Community Development Department

Notice of Decision Trailer Sales Site Plan Review

Land Use Application Nos.:SPR 20-008 (Site Plan Review) SEP 20-011 (SEPA)Applicant:Jeff Zimmerman T2 Investments LLC P0 Box 2128 Woodland, WA 98674Property Owner:James Chumbley 11804 Marine View Dr. Edmunds, WA 98026Site Location:2250 Robinson Road Woodland, WA 98674Parcel No. & Size:507670100, 2.77 acresZoning Designation:C-2, Highway CommercialDate Application Received:September 4, 2020Notice of Complete Application Issued:September 8, 2020September 8, 2020September 8, 2020 (Comment deadline) October 20, 2020 (SEPA deadline)Notice of Decision Issued:June 15, 2021DRC DecisionApprove with Conditions		
Applicant:Jeff Zimmerman T2 Investments LLC PO Box 2128 Woodland, WA 98674Property Owner:James Chumbley 11804 Marine View Dr. Edmunds, WA 98026Site Location:2250 Robinson Road Woodland, WA 98674Parcel No. & Size:507670100, 2.77 acresZoning Designation:C-2, Highway CommercialDate Application Received:September 4, 2020Notice of Complete Application Issued:September 8, 2020September 8, 2020September 8, 2020Notice of Application & Likely DNS issued:September 16, 2020 (Comment deadline) October 20, 2020 (S

Attachment A Site Plan

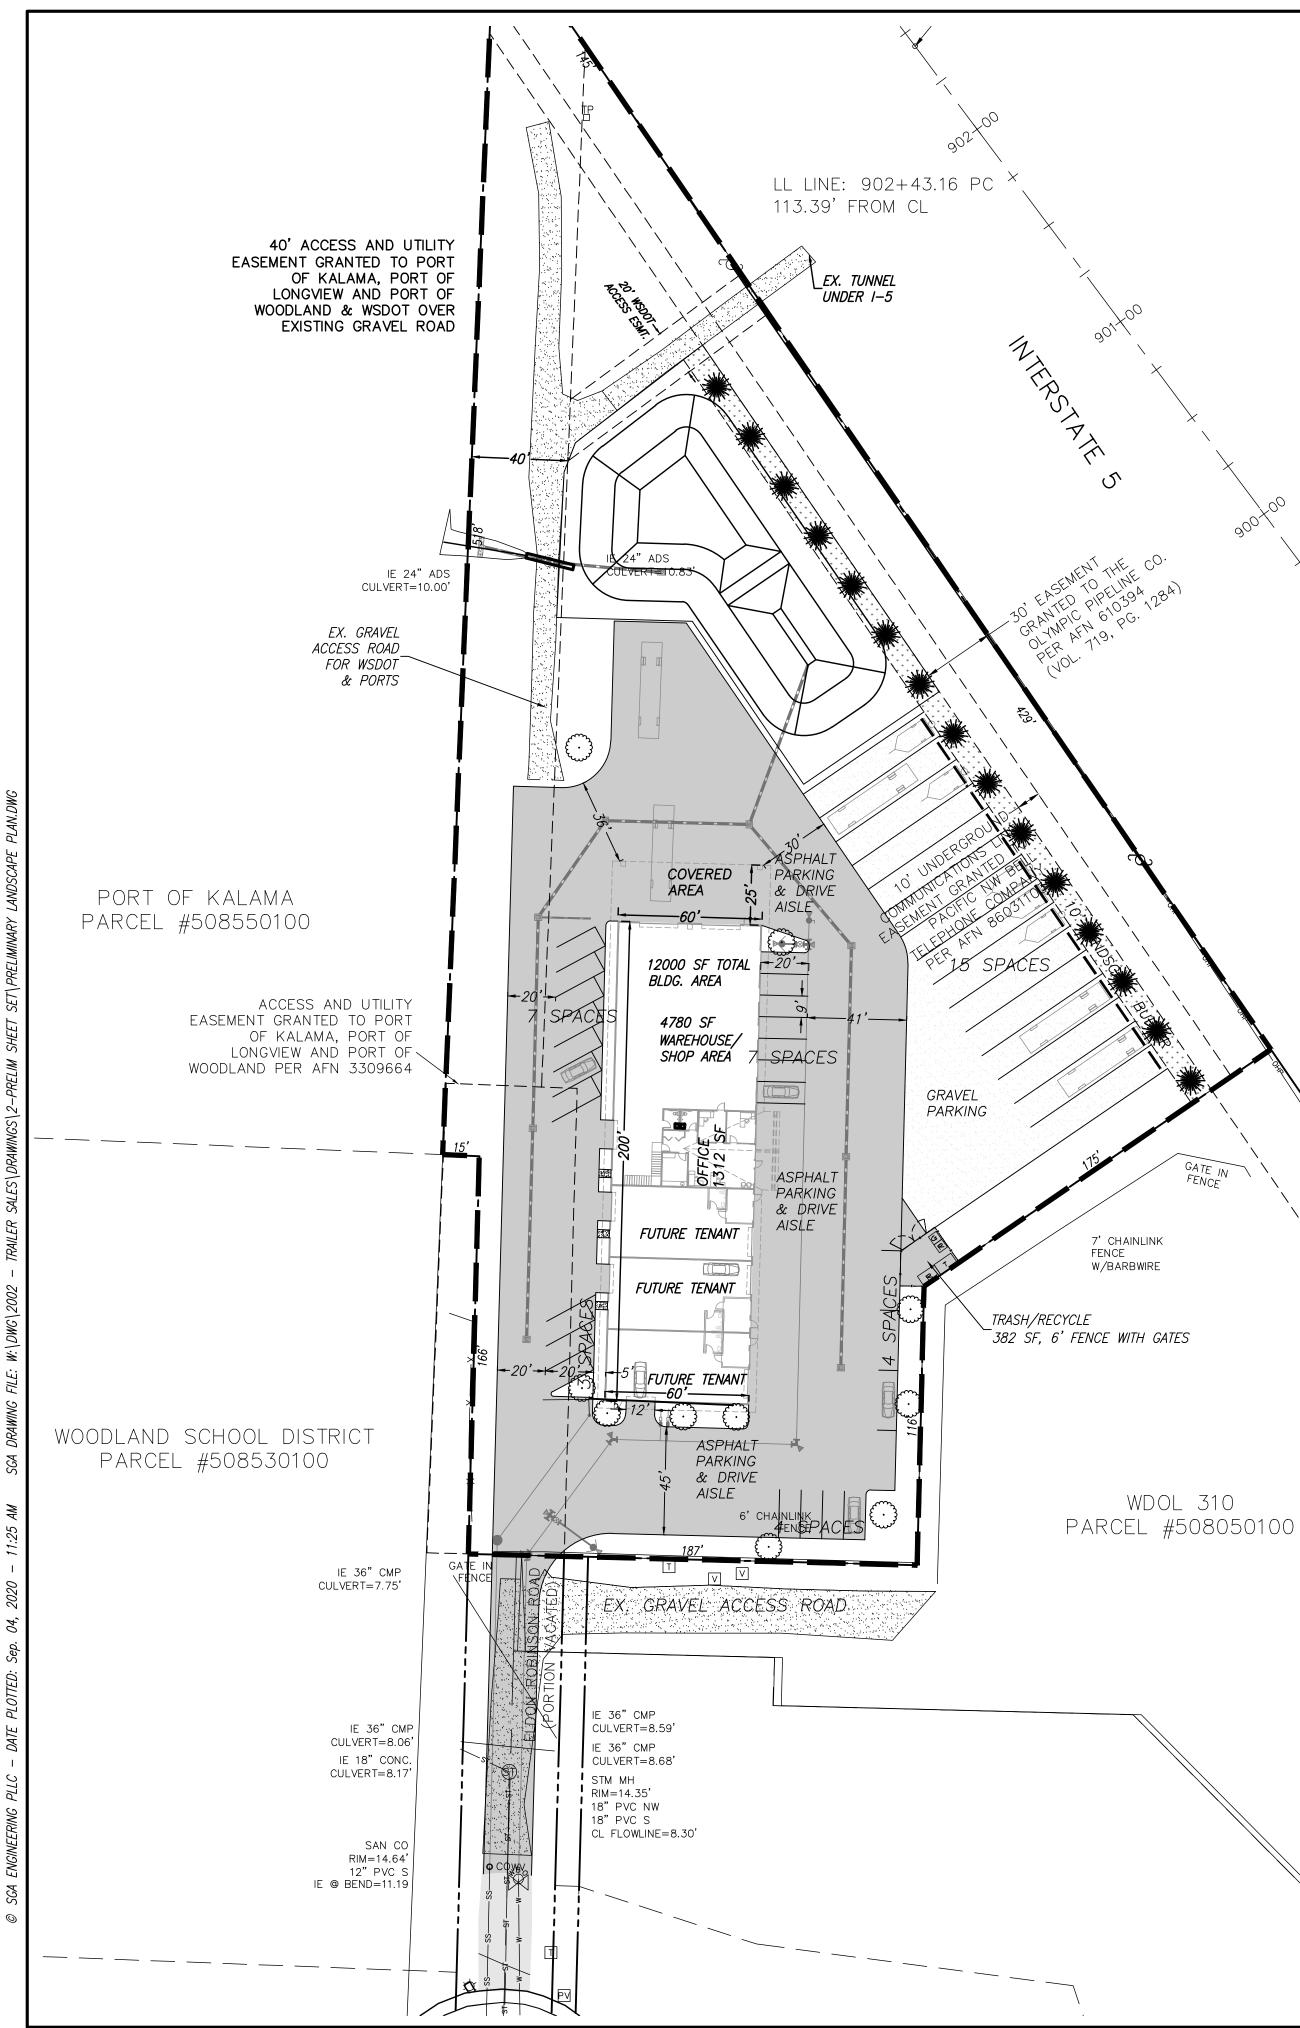
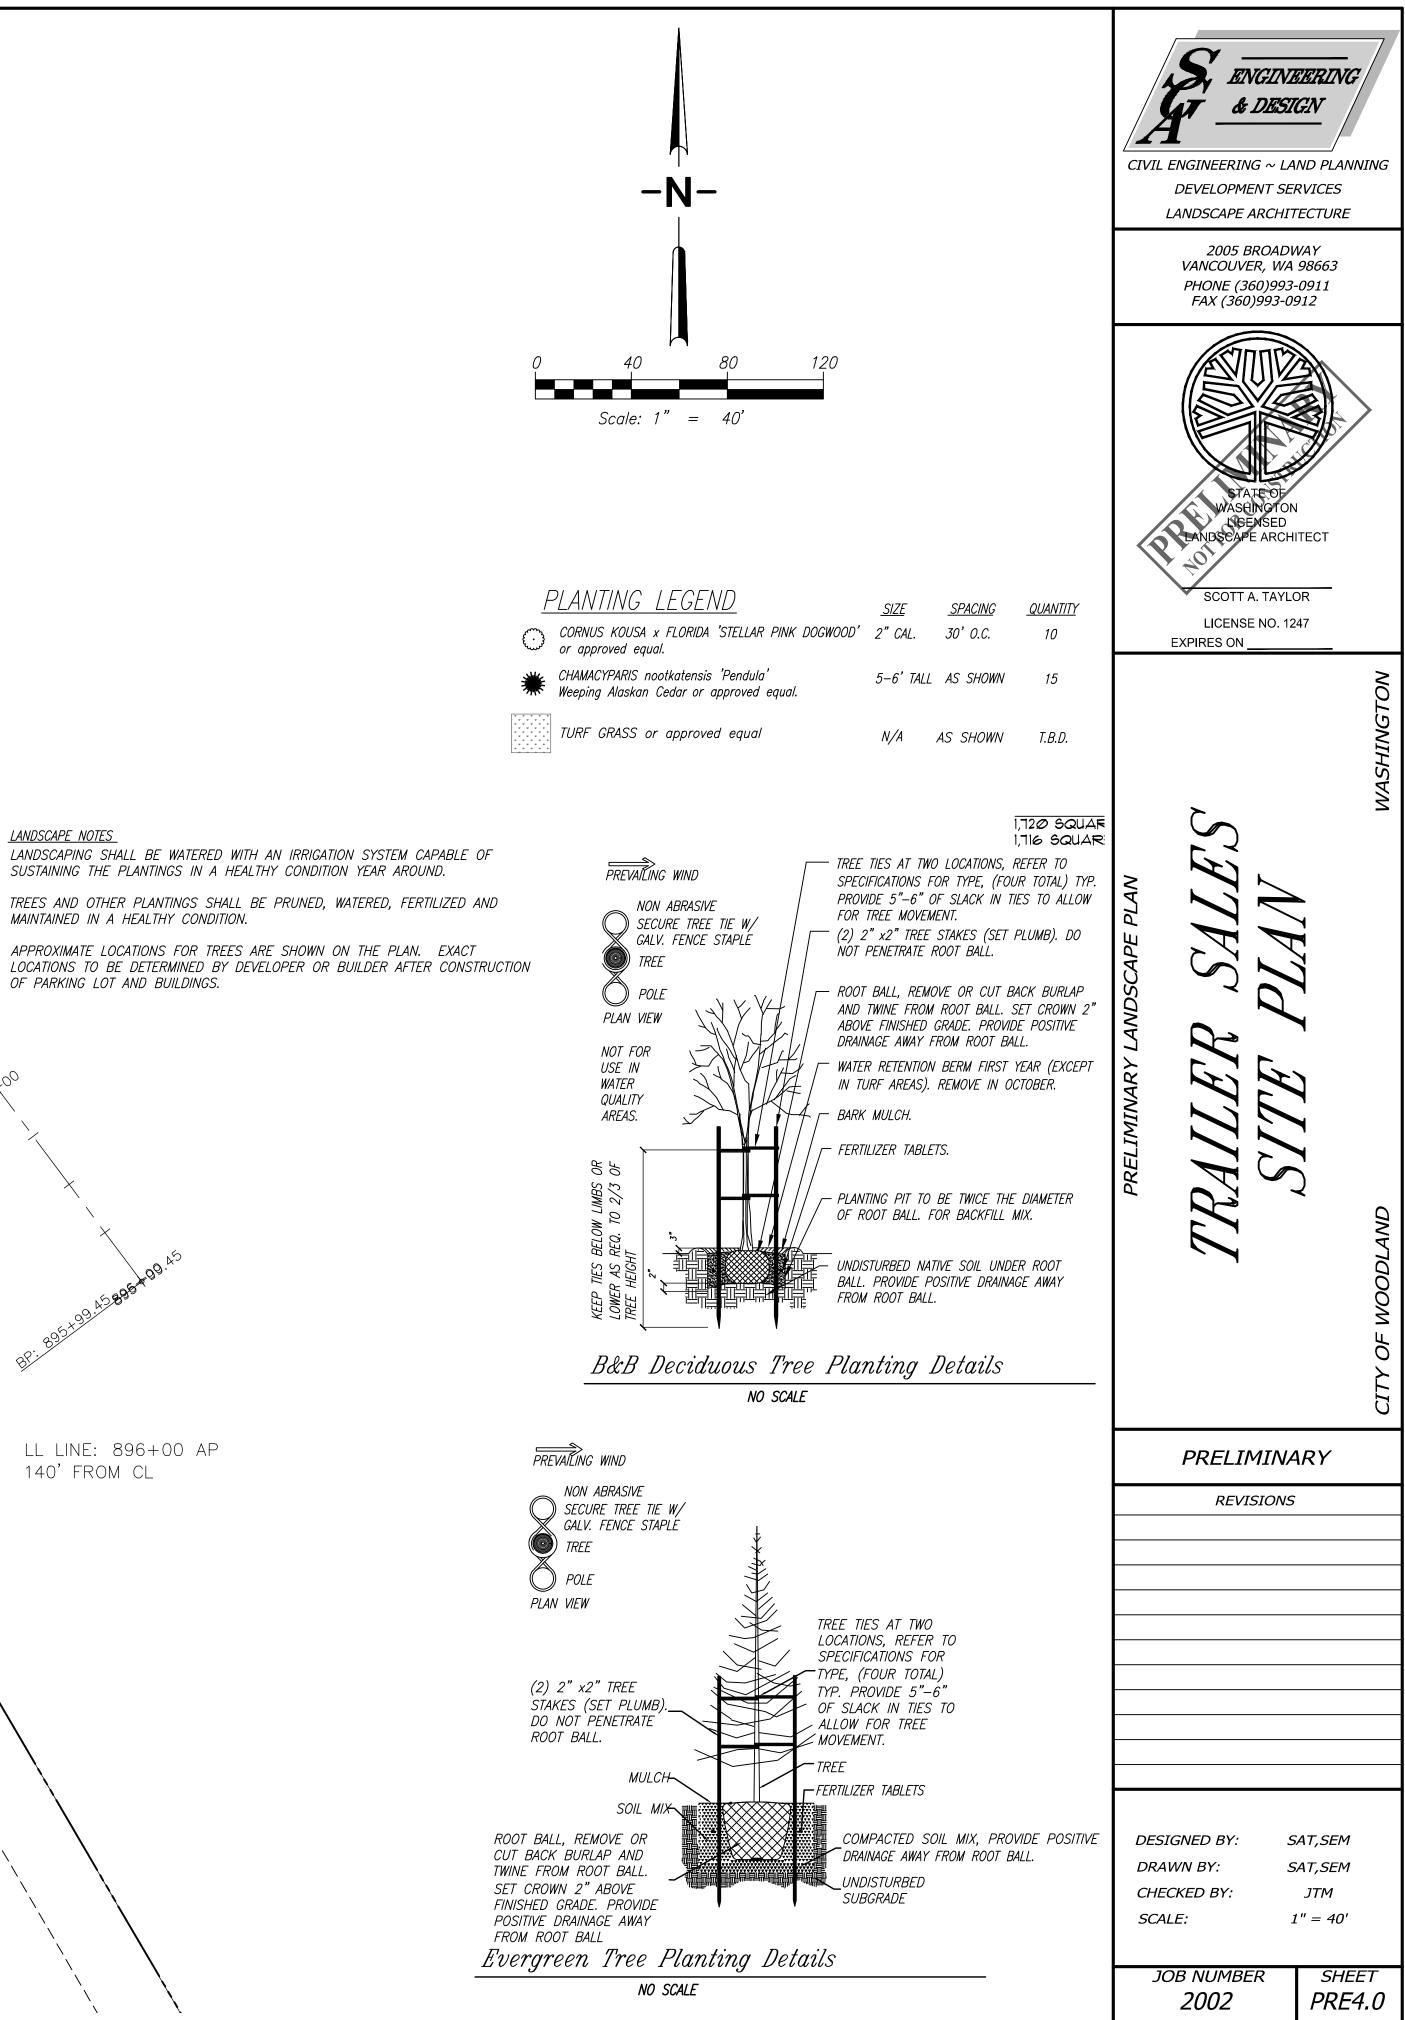
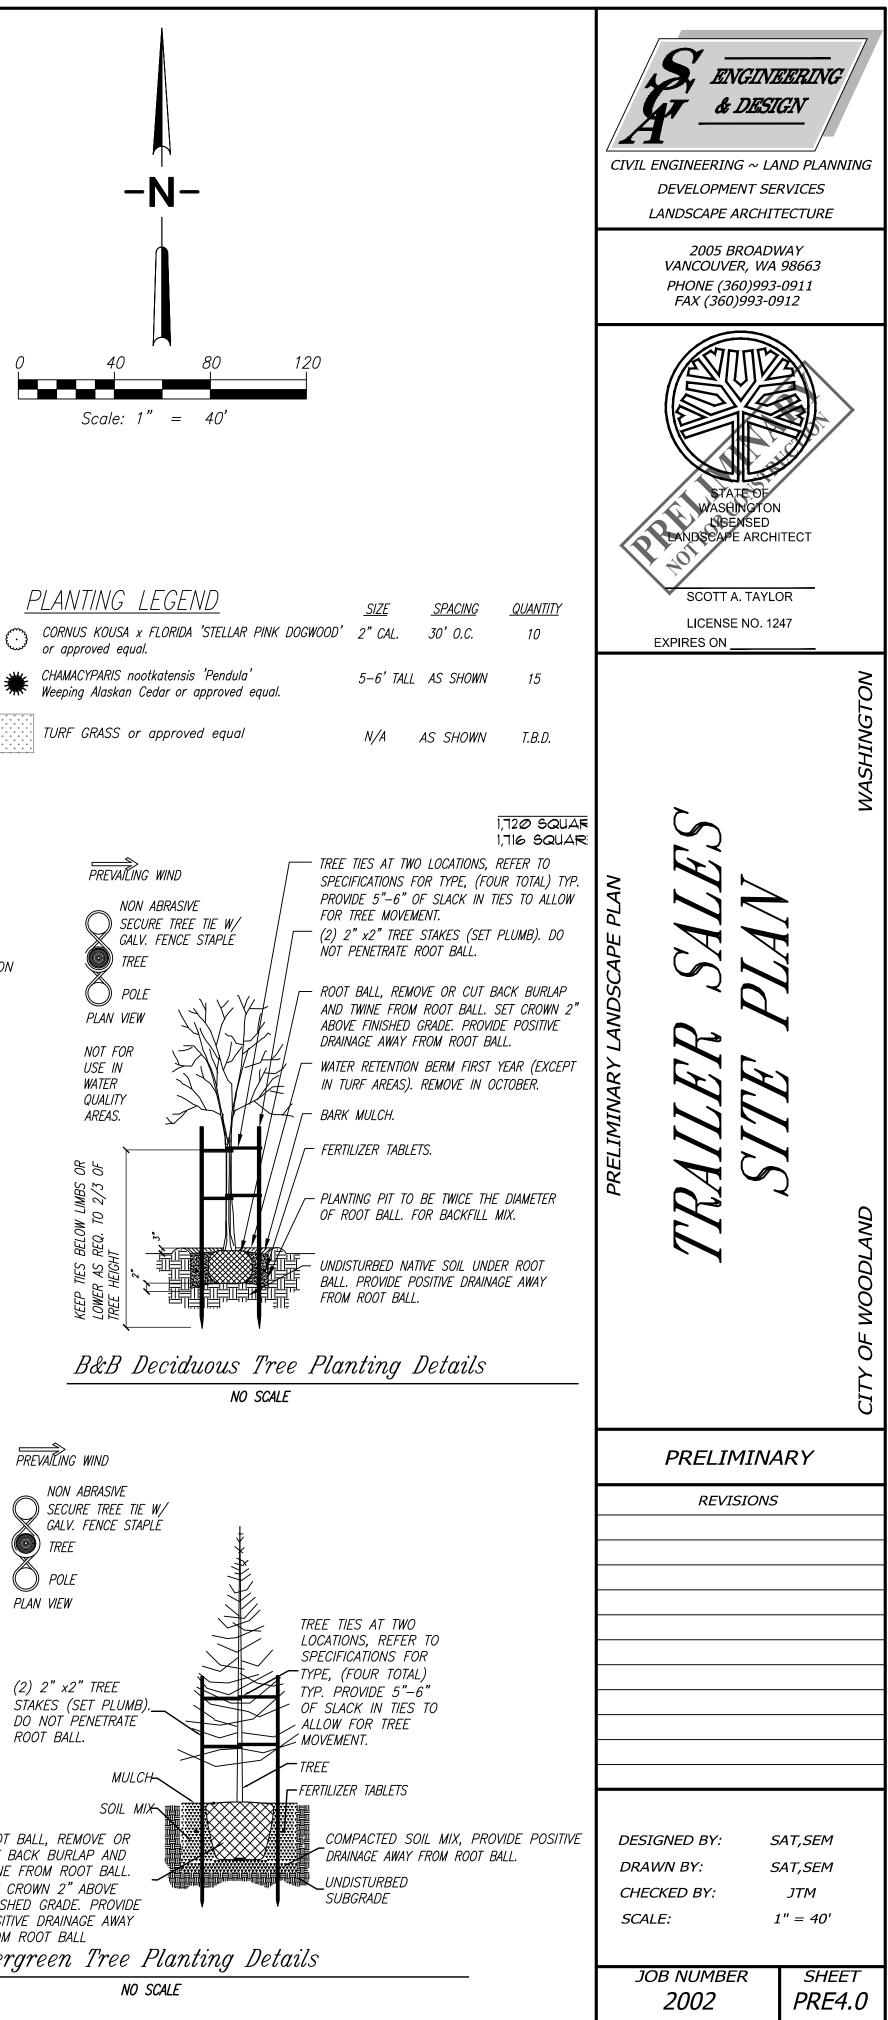
Finding 20: The proposed building is located beyond the north end of a culdesac down a 130 ft. driveway. Locating near the fronting street is not possible and the requirement is waived. *See Attachment A – Site Plan.*

Finding 31: A 10 ft. wide landscaping strip is proposed between I-5 and the parking lot and contains Weeping Alaskan Cedar. *See Attachment A – Site Plan.*

Finding 39: The building entries are easily identifiable from the parking lot and it is not feasible for the entries to be easily identifiable from the street. Weather protection is lacking and a condition is added to add weather protection to the building elevations meeting requirements of WMC 17.36.130 (G)(1) and (2) and resubmit with the final engineering.

Finding 41: The transparency standard, WMC 17.36.130 (H)(4), is not met. A condition is added to meet the transparency standard by providing additional windows or blank wall treatments to the east elevation per WMC 17.36.130 (H) (5). *See Condition #15.*

Finding 43: Pedestrian connections between tenants and the parking lot are lacking on the proposed site plan. A condition is added to include sidewalk along the east elevation that connects all tenants, parking, and accessible parking spaces on the site plan. Pedestrian connections shall be not less than five feet wide should be clearly defined using two or more of the options listed in WMC 17.36.130 (M)(2). *See Condition #16.*

Finding 45: There is a 10 ft. wide landscaping strip shown on the site plan between the parking lot and I-5. *See Attachment A – Site Plan.*

Finding 47: An enclosure is indicated for this area on the site plan but the materials to be used for screening are not described in the narrative or building elevation. A condition is added to include the enclosure in the building elevation document and describe method chosen for meeting WMC 17.36.130 (P) and resubmit with civil engineering plans. *See Condition #17.*

- 11. Submit a final Stormwater Technical Information Report (TIR) for this project.
- 12. Include 40 paved parking spaces on the site plan and clearly indicate the location and size of the parking spaces. Submit the revised site plan with the civil engineering plans. Alternatively, submit a parking study demonstrating a need for less parking spaces and seek approval from the Community Development Director.

- 13. To meet International Building Code sections 1106.1, 1106.5, 1106.6 & 1106.7 for required accessible parking spaces, two accessible spaces are needed of which one must be van accessible. Accessible parking spaces shall be located on the shortest accessible route of travel from adjacent parking to an accessible building entrance. Where buildings have multiple accessible entrances with adjacent parking, accessible parking spaces shall be dispersed and located near the accessible entrances. Include accessible spaces on a revised site plan and submit for civil review.

- 14. Revise the site plan with pedestrian amenities per WMC 17.36.130 (F) and include in the civil submittal. A 120 sq. ft. plaza/courtyard is required with pedestrian amenities.

- 15. Meet the transparency standard, WMC 17.36.130 (H)(4), for the east elevation by providing 20% transparency for the façade between 3 ft. and 7 ft above grade by providing additional windows or blank wall treatments per WMC 17.36.130 (H)(5). Revise the site plan and include with the engineering review submittal.

- 16. Include sidewalk/walkway along the east elevation that connects all tenants, parking, and accessible parking spaces on the site plan. Pedestrian connections shall be not less than five feet wide should be clearly defined using two or more of the options listed in WMC 17.36.130 (M)(2).

- 17. Include the enclosure in the building elevation document and describe method chosen for meeting WMC 17.36.130 (P). Resubmit with civil engineering plans.
